1026-101

RF Keyboard

Sheet 3

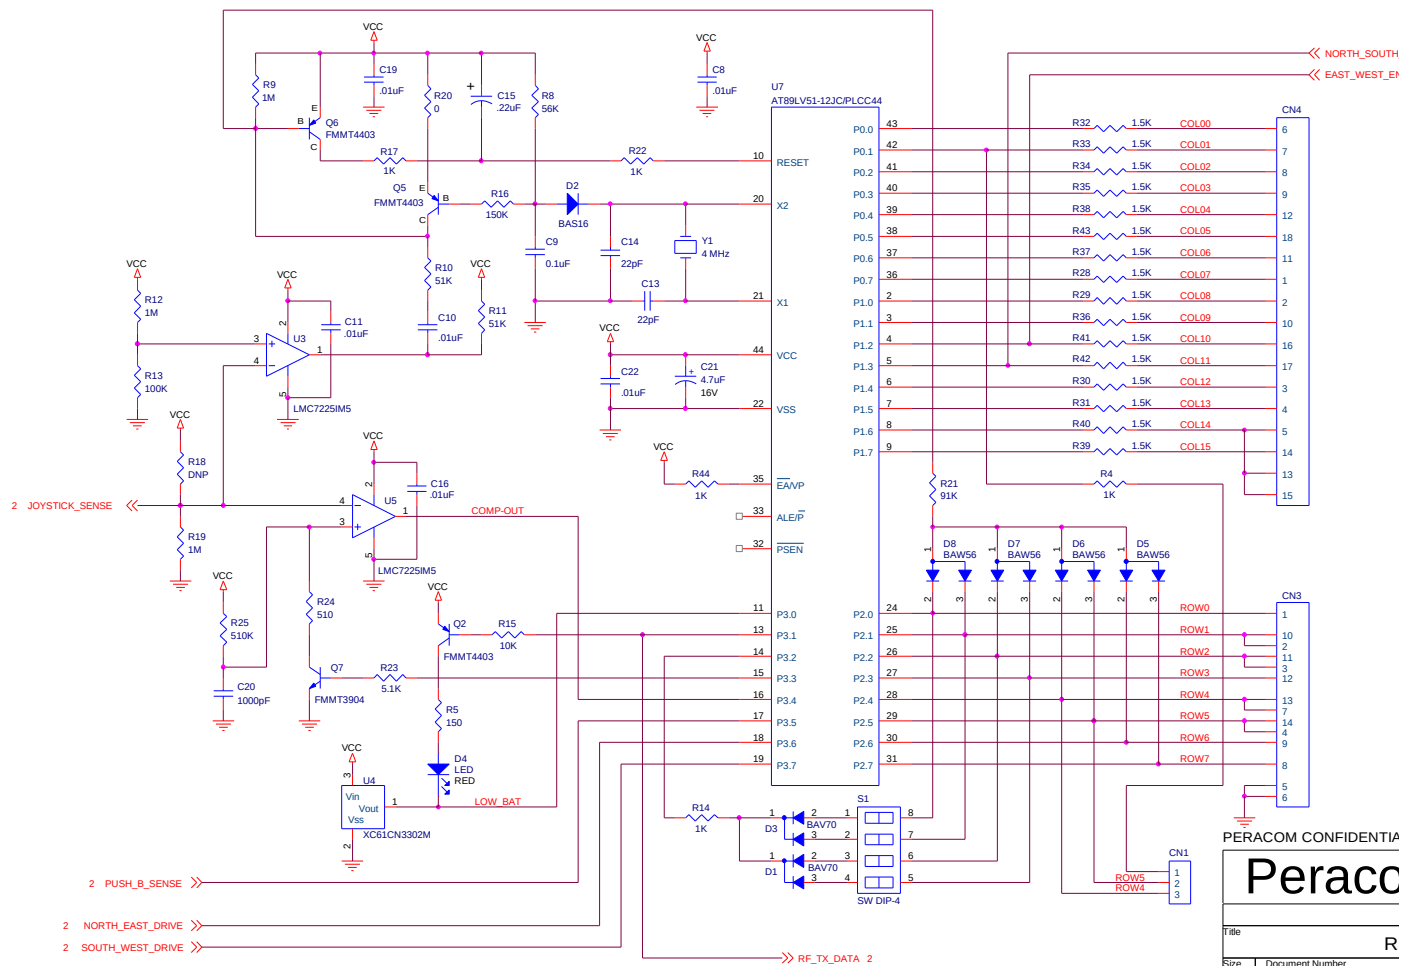
Rev	Description
D	Changed keypad connections: Pin 4 to COL13 and Pin 5 to COL14 Changed NE and SW to U7-3.6 & U7-3.7 Moved mouse Button Com to U7-0.1 Added battery terminal pads E2 & E3
E	Added Thermal Relief to E3
